**ADDENDUM NO. 3
MPR HVAC FOR BEN LOMOND, CYPRESS, GROVECENTER, ROWLAND AND
WORKMAN ELEMENTARY SCHOOLS
BID NO. 22-23-126**

August 11, 2023

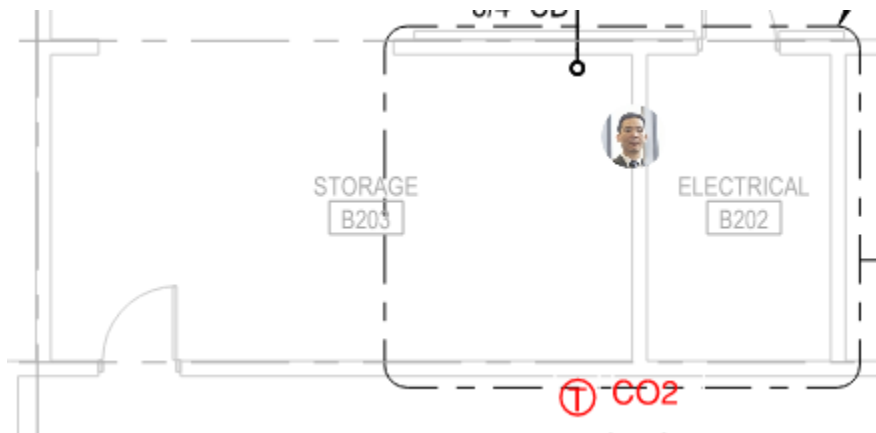
Question #25: Per M1.1A Ben Lomond, demolition notes, we need to demolish the existing EF, floor plans show an EF installed in the new system, equipment schedule does not show any EF. Please advise if the existing EF is to be removed and replaced, if it does, please provide the EF equipment schedule.

Clarification #25: EF schedule is included in the DSA Submittal Set dated 03/16/2023. Here is the schedule... Loren Cook model 270SQN-HP, 2500 CFM, 0.5 ESP.

EXHAUST FAN SCHEDULE																								
NOTES: 1. 2. 3. 4. 5.																								
ID	DESCRIPTION	LOCATION			TYPE	FAN DATA							ELECTRICAL DATA						BASIS OF DESIGN					
		NO.	NAME			DESCRIPTION	AIR FLOW (CFM) DESIGN	ESP (IN WG)	RPM	DRIVE TYPE	QTY	HP	HP Input	RPM	ECM	FLA (A)	FLA Input	MCA (A)	MOCF (A)	VOLT (V)	PH	WEIGHT (LBS)	MANUFACTURER	MODEL
EF-B1	EXHAUST FAN	B201	MECHANICAL ROOM		CENTRIFUGAL INLINE	CENTRIFUGAL	2,500	0.5	526	BELT	1	0.5	0.5	1725	No	9.8	9.8	12.3	15	115	1	428	LOREN COOK	270SQN-HP
